Access Compliance Report

Public Rights-of-Way

Intersection ID: N/A	Main Street: ARBOR_LOOP_DR	Cross Street: ANSLEY_GARDEN_DR	Location: NW
ADA ID: 1BEDD1EF3BE0	Ramp Type: Directional1	Initial Pass/Fail: Fail	Overall Compliance: No
			Severity Score: 13.75

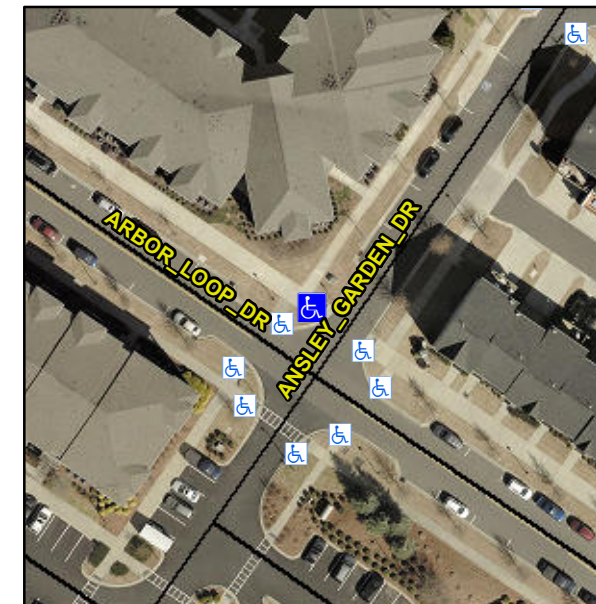
R304.2.2, R304.5.3

Compliance	Description	Data	Compliance	Description	Data
N/A	Ramp Length (in)	76.0	N/A	Grade Break?	N/A
Yes	Ramp Width (in)	120.0	N/A	Grade Break Slope (%)	0.0
No	Ramp Slope (%)	8.9	N/A	Grade Break XSlope (%)	0.0
No	Ramp XSlope (%)	2.8			
N/A	Flare Type LT	N/A	N/A	Flare Type RT	N/A
N/A	Flare Slope LT (%)	N/A	N/A	Flare Slope RT (%)	0.0
N/A	Flare Traversable LT?	N/A	N/A	Flare Traversable RT?	N/A
N/A	Landing Length (in)	0.0	N/A	DWS Provided?	N/A
N/A	Landing Width (in)	0.0	N/A	DWS Contrast?	N/A
N/A	Landing Slope (%)	0.0	N/A	DWS Length (in)	N/A
N/A	Landing X Slope (%)	0.0	N/A	DWS Full Width?	N/A
N/A	Landing Curb? (Y/N)	N/A	N/A	DWS Offset LT (in)	N/A
N/A	Shared Landing?	N/A	N/A	DWS Offset RT (in)	N/A
N/A	Gutter Ponding?	0.0	N/A	Gutter Slope (%)	N/A
N/A	Gutter Lip Ht (in)	0.0	N/A	Gutter X Slope (%)	N/A
N/A	Painted X Walk1?	No		Road Slope (%)	0.8
	X Walk 1 Direction	To E		Road X Slope (%)	0.3
	X Walk 1 Width (in)	N/A		Clear Space?	N/A

Remove & Replace Entire Ramp.
